# OAK RIDGE NATIONAL LABORATORY

September 14, 1982

The results of LOFT test L2-5 raise some question about the assumptions of all three PWR vendors that the indications of the core-exit thermocouples can be used as an unambiguous indication of approach to ICC, at least during the recovery period from a large break LOCA when there is still a significant amount of residual decay heat in the core.

Figure 19. Comparison of cladding temperatures at different elevations during second core heatup for Experiment L2-5.

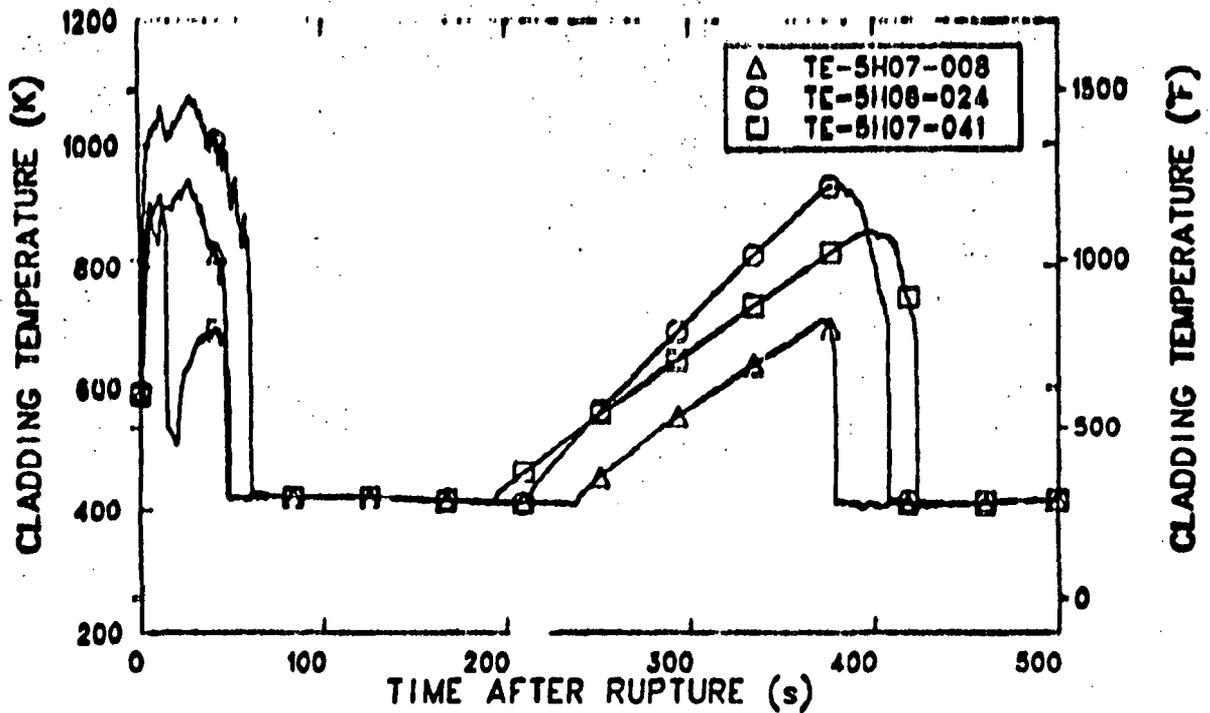
The EG&G Quick-Look Report (EGG-LOFT-5921, June 1982) states the conclusion: "The temperature information observed by reactor operators for liquid level control (upper plenum) and also coolant temperature information at the core-exit are shown in Fig. 20 (attached). Comparing this information with that in Fig. 19 (also attached), clearly shows that these temperature measurements are not adequate for liquid level control and, hence, maintaining adequate core cooling." From these curves it is apparent that during the second core uncovering the upper plenum temperature did not depart significantly from the saturation temperature and that the core-exit temperature showed superheat only after the cladding temperature started down due to reflooding from reestablished injection flow. Examination of additional temperatures in the L2-5 Data Report (NUREG/CR-2826, EGG-2210, August 1982) shows a close correlation between the rise in core-exit temperature (e.g., Fig. 3R-7) and reestablishment of LPIS flow (Fig. 3R-1). Similar examination of the initial blowdown shows a possible correlation between core-exit temperature rise and the initiation of HPBI flow. A significant amount of top-down quenching was noted to occur during the blowdown phase. It is observed that the central lower end box (assembly 5) coolant temperatures showed superheat during the initial blowdown while the central upper end box temperatures showed virtually no superheat. In the outer assemblies, the superheat was at the top with little or none at the bottom.

Figure 20. Comparison of core exit and upper plenum fluid temperatures with saturation temperature for Experiment L2-5.

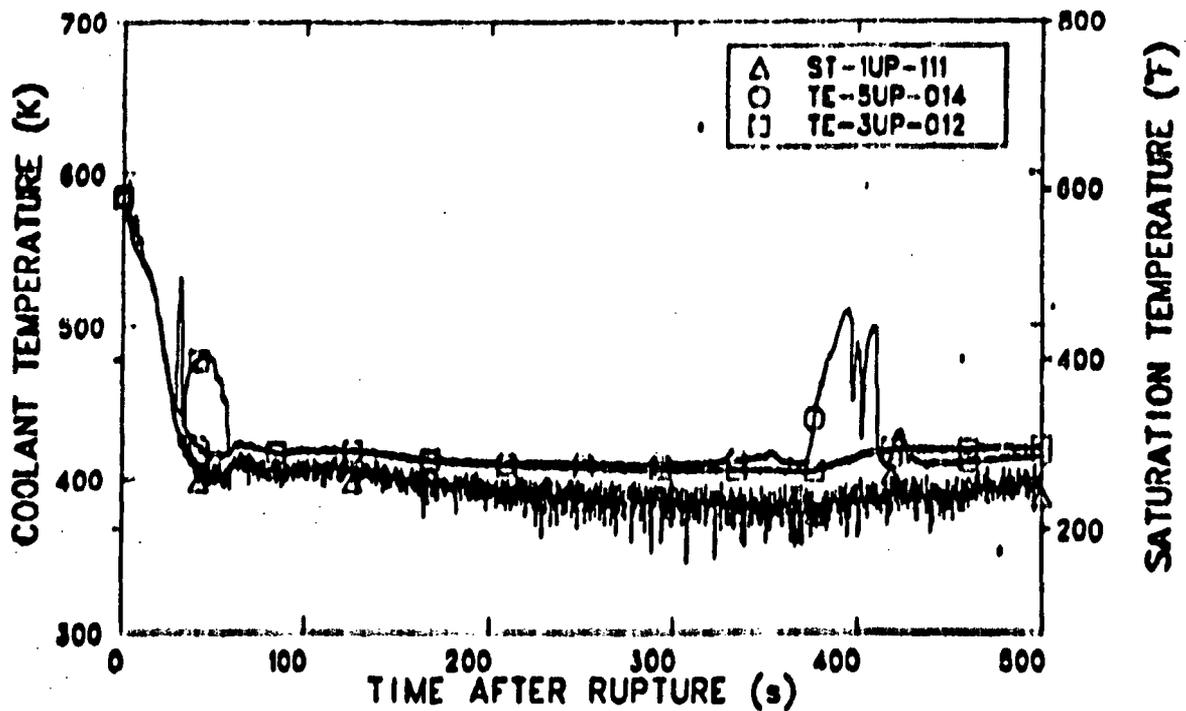
It is speculated that when the vessel level is decreasing in the core region that reverse flow or stagnation may be occurring possibly in conjunction with top quenching, which effectively inhibits superheat indication of the core-exit thermocouples or upper plenum temperatures. When HPIS or LPIS flow is established, then at least the outer fuel assemblies show superheat at the upper end boxes.

It is not clear that the failure of the core-exit thermocouples to show the approach to inadequate core cooling in this large LOCA transient can be extrapolated to the small break case. Some additional testing with slower core uncover would be in order.

Perhaps the PWR vendors should be asked to analyze LOFT L2-3 with respect to the use of core-exit thermocouples to indicate ICC and show that their emergency guidelines cover situations such as occurred in the LOFT test.
